Bayside Planning Panel

Item No	5.2
Application Type	Development Application
Application Number	DA-2016/150
Lodgement Date	22 October 2015
Property	401-405 Princes Highway, Rockdale
Owner	Mr & Mrs Ibrahim & Ibrahim Pastry Pty Ltd
Applicant	Architecture & Building Works Pty Ltd
Proposal	Integrated Development - Construction of part 8, part 11 storey mixed use development comprising 57 residential units and 2 commercial units with basement parking.
No. of Submissions	1
Cost of Development	\$17,219,801
Report by	Fiona Prodromou, Senior Assessment Planner

Planning Assessment Report

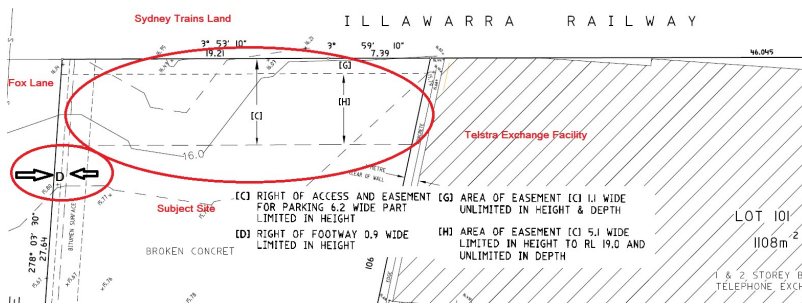
Comment: Fox Lane comprises a variable width of 5.825m at the western end and 6.1m at the eastern end at the junction with the Princes Highway. Plans do not seek to widen the existing lane width as suggested by the DRP. Plans illustrate a 3m building setback at ground level to Fox Lane, with an associated pedestrian pathway and landscaping proposed, all within the property boundaries of the subject site. Proposed finishes, levels and specifications of any kerb / gutter and any associated stormwater works likely to be required within Fox Lane have not been submitted for assessment. The entire length of the southern boundary of the site is burdened by Telstra easements for drainage and a right of footway which benefits Bayside Council. As such the current design conflicts with these easements.

Plans further illustrate that the proposed building form beyond the Fox Lane lift core, maintains a breach to the height standard as can be identified in yellow and illustrated in the southern elevation below. This is contrary to the comments of the Design Review Panel and is not supported. Further, units 8.4 and 9.4 have not been deleted as suggested by the DRP. Revised plans illustrate the provision of the required 3m building setback from the front property boundary, with basement levels below also setback 3m from this front boundary, in order to facilitate Councils Princes Highway Green Gateway Vision and enable the planting of trees in deep soil on site.

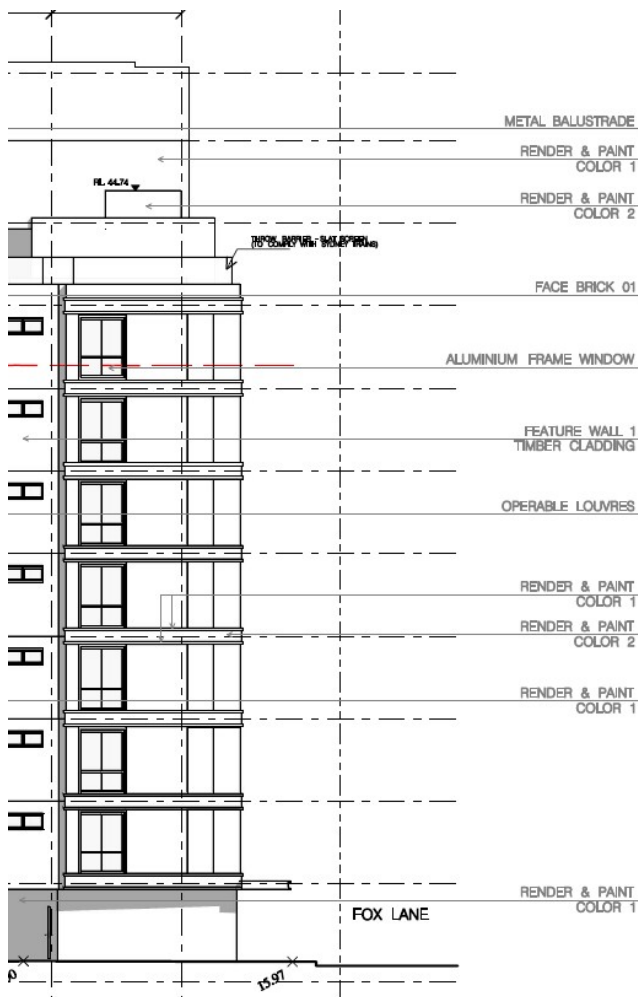
The proposal provides a 3 storey podium, recessed 3m from the front property boundary, with levels 4 and above recessed a further 3m as required by this clause.

Level 4 and above is setback 4.5m from the northern common side boundary of the site as required by the provisions of this clause.

01 JUNE SHADOWS 09:00 AM
SCALE 1:400@A1 1:800@A3

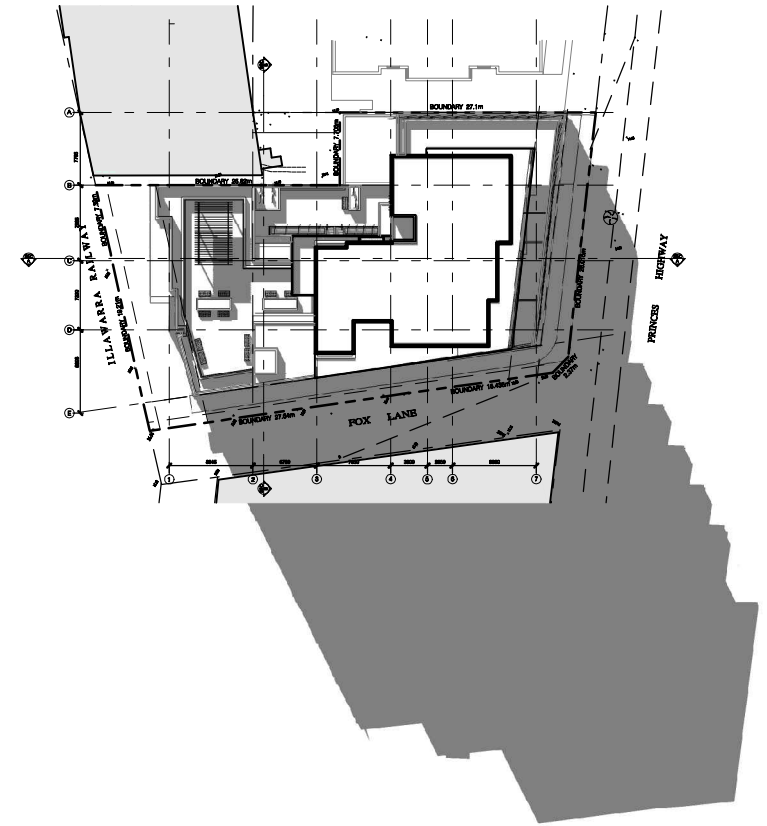
A review of the applicants submitted revised shadow diagrams confirms that solar access is achievable in midwinter to this seating area as a result of the 'glass roof' as proposed. A review of the of the shadow diagrams for the final approved development upon 397 Princes Highway, the northern adjoining site however illustrates that this is not the case as the approved development form upon the neighbouring northern site and existing Telstra Exchange facility to the west overshadow the glass roof and rear façade of this 'outdoor seating area' in midwinter, albeit for a small portion at 12pm.

Comment: 'solar access' plans submitted to Council seek to illustrate the number of units within the development which receive a minimum of 2 hours of access in midwinter. These diagrams do not accurately depict the approved building form upon the northern adjoining site. As such an accurate assessment of the number of units within the development receiving adequate solar access in midwinter is unable to be ascertained.

LANDSCAPE PLAN		DWG: IS0181DA2
FIRST FLOOR		ISSUE: C
401-405 PRINCES HIGHWAY, ROCKDALE 2216		
DATE:	MAY 2016	
SCALE:	1:100@A1

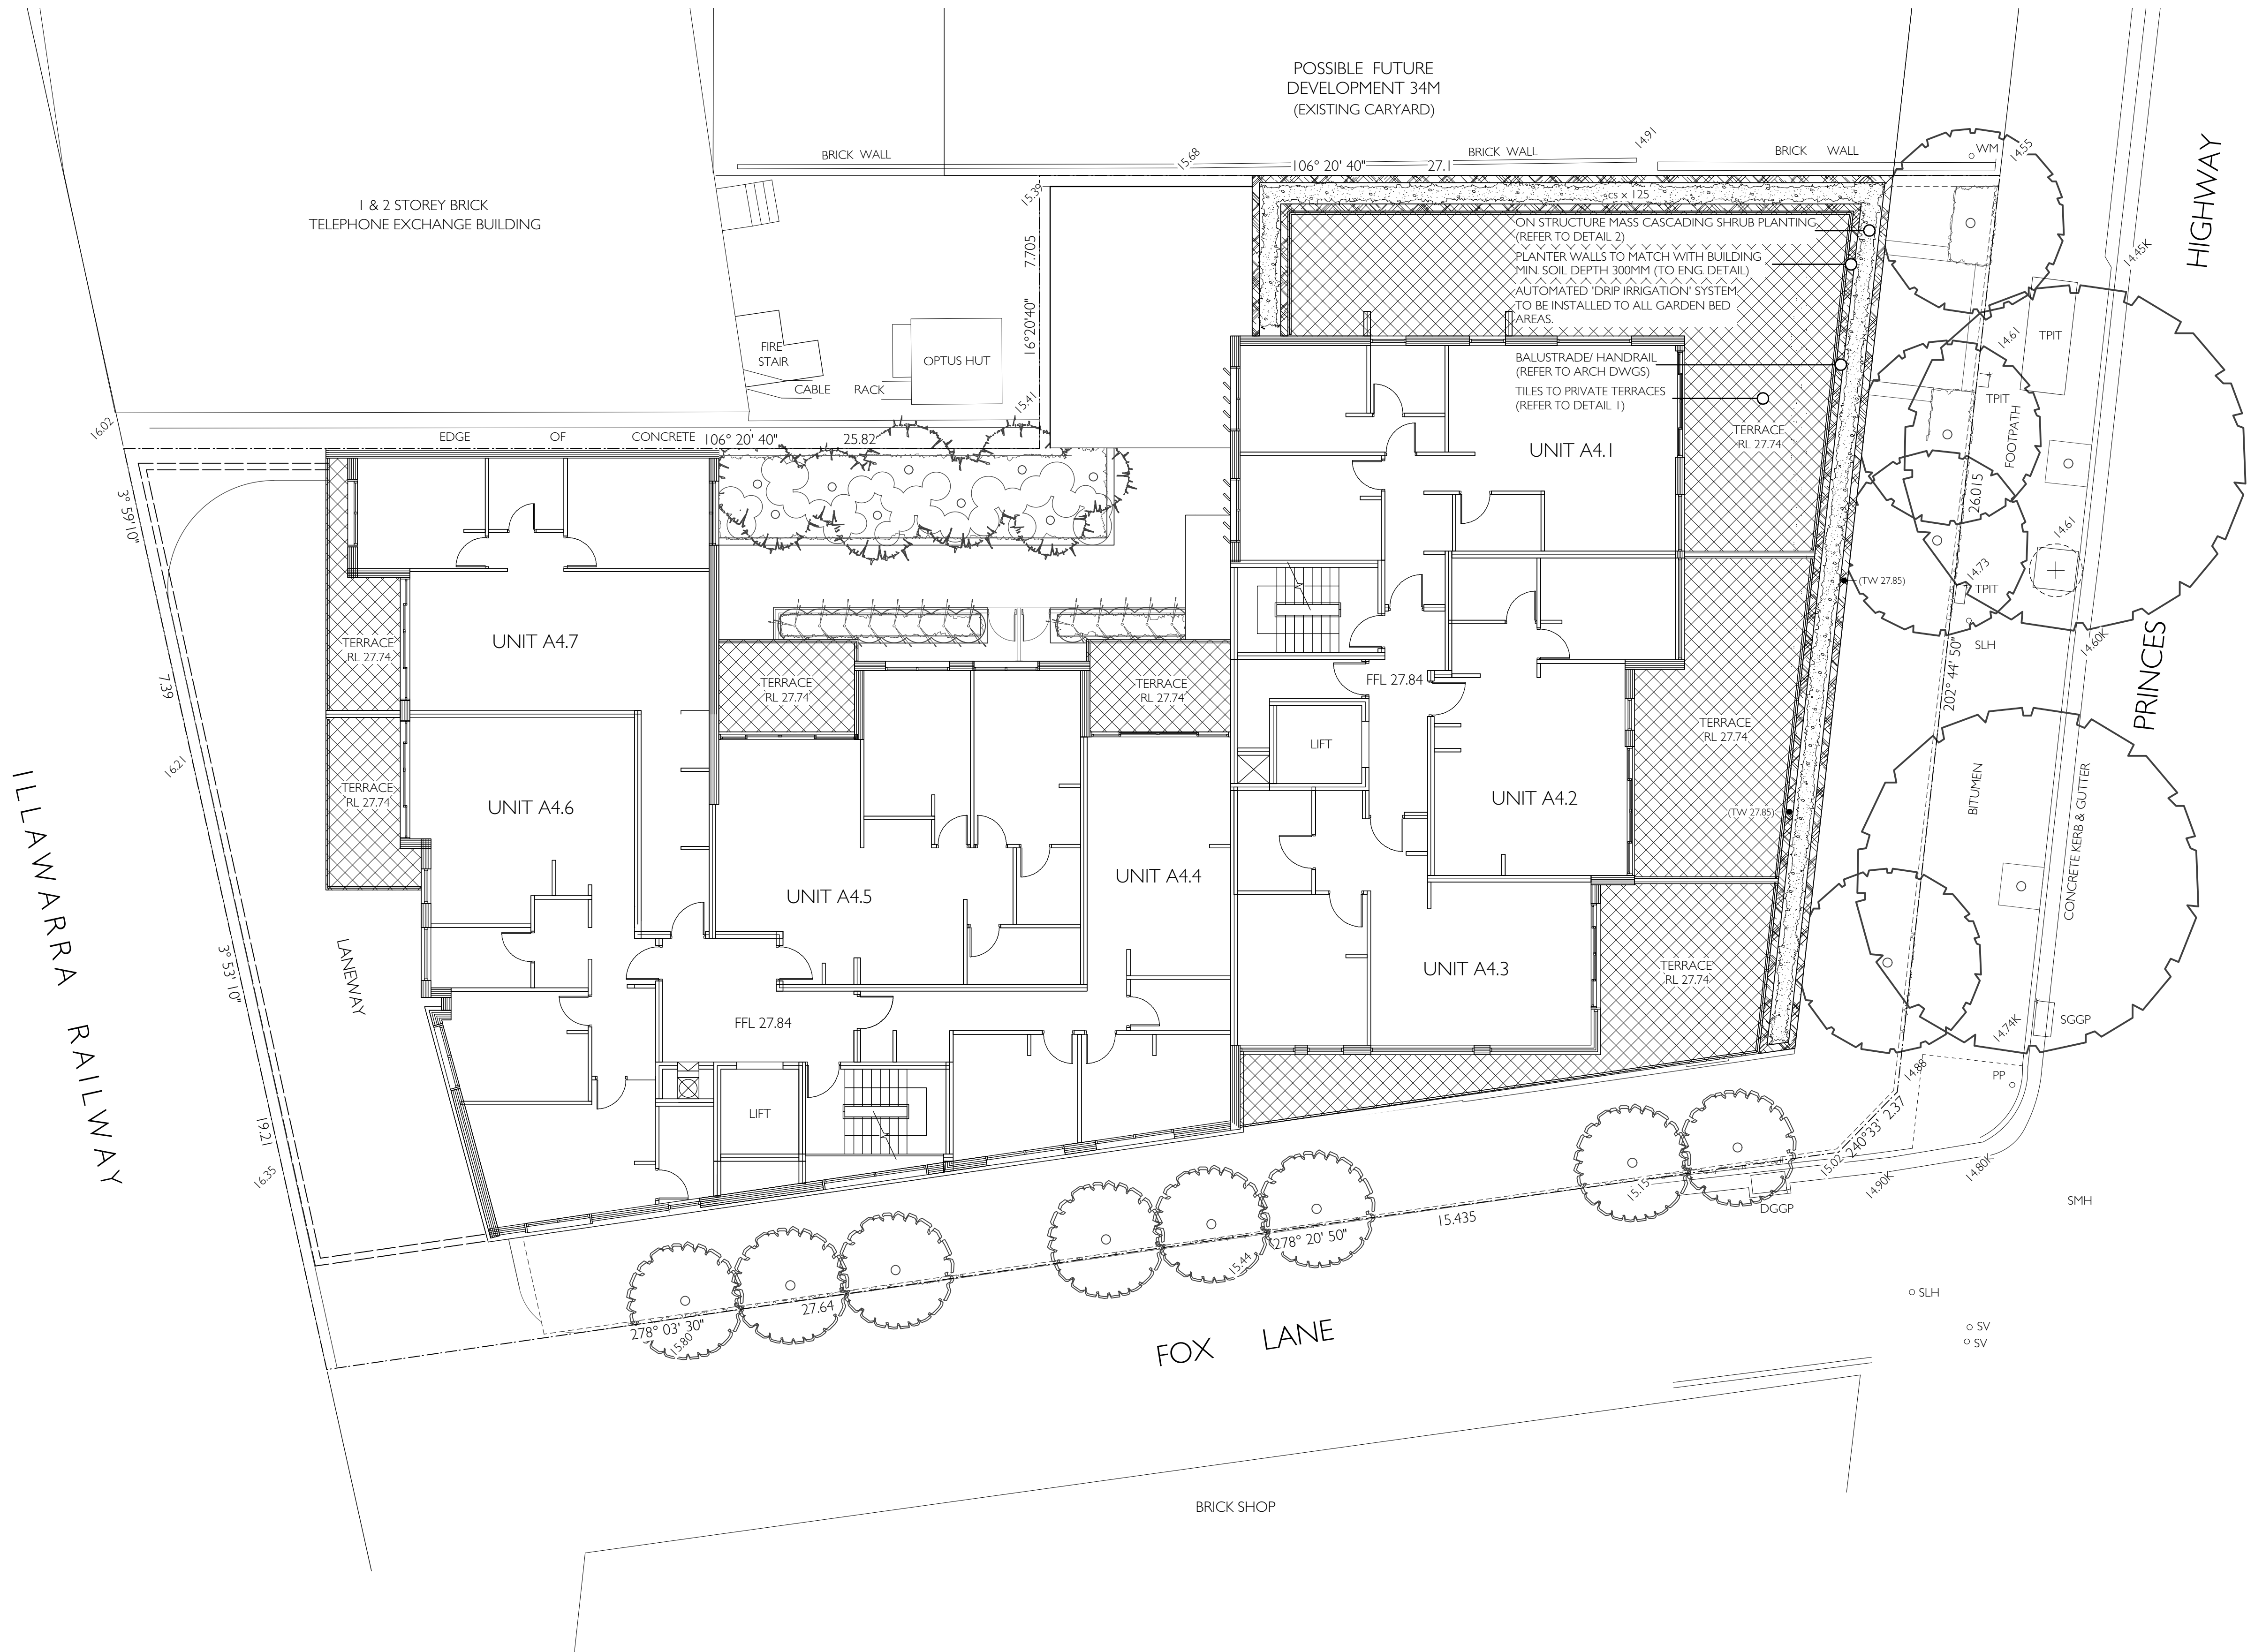
Comment: Plans do not address the above and retain the L1 area as communal open space contrary to the panels recommendation.

Comment: The level 1 communal open space area proposed comprises a total area of 72sq/m. Of this, 30sq/m comprises a raised mass planter with the remaining area being irregularly shaped and no greater than 1.7m in overall width. The location, design and configuration of this COS area is not appropriately designed so as to be functional, encourage social interaction and maximise amenity for future occupants.
